CORPORATION
Crystal River Unit 3
Docket No. 50-302
Operating License No. DPR-72

June 1, 2000
3F0600-07

Subject: License Amendment Request #256, Revision 0
Extension of Containment Sump Monitor Channel Calibration Interval

Figure 1
Containment Sump Monitor Instrumentation String

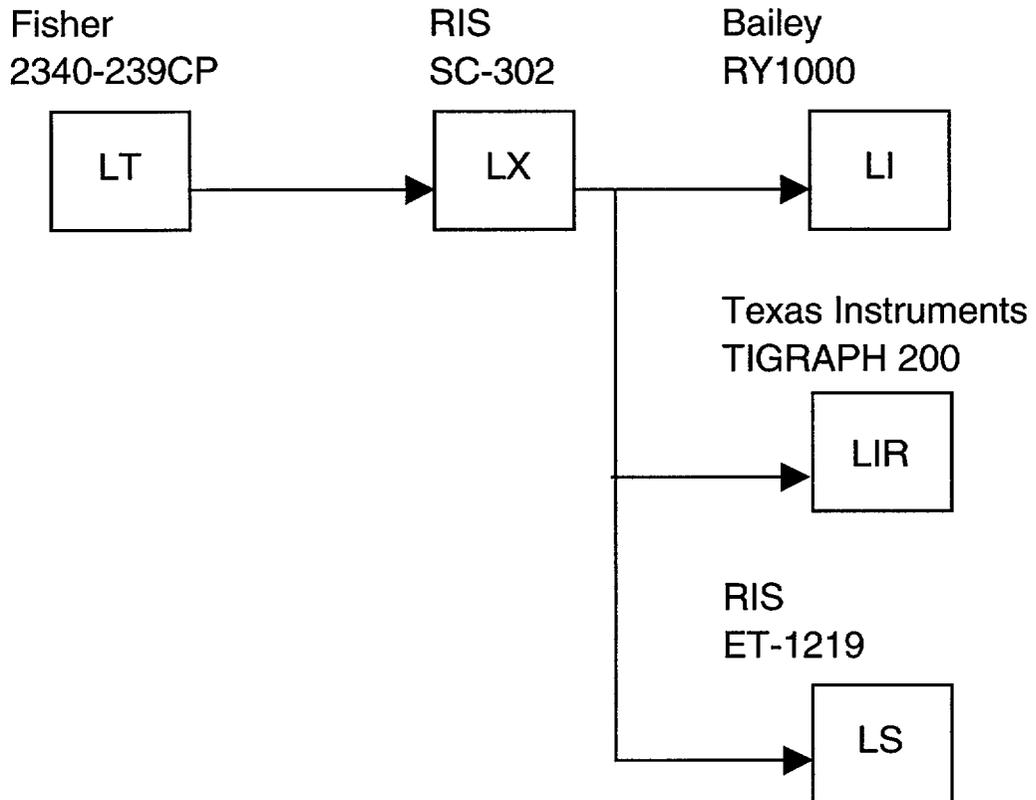
Surveillance Requirement (SR) 3.4.14.3 requires channel calibration of the containment sump monitor. The containment sump monitor instrumentation string is used to satisfy the requirements of Improved Technical Specification (ITS) Limiting Condition for Operation (LCO) 3.4.14 for Reactor Coolant System (RCS) leakage detection. The current required interval for the calibration is 18 months. The requested change is to extend this interval to 24 months. This instrument is used principally for identifying changes in the containment sump level that occur over short time intervals, e.g., an operating crew shift, rather than measurement of a specific, required level. Any greater instrument drift that might occur as a result of the 24-month calibration interval will not materially affect the capability of the instrument to provide accurate level trend data.

The containment sump level instrumentation is used to detect trends and changes in the sump level rather than an absolute level. The containment sump monitor instrumentation string, including the level transmitter, signal converter, level indicator, level recorder, and level switch are shown schematically in Figure 1.
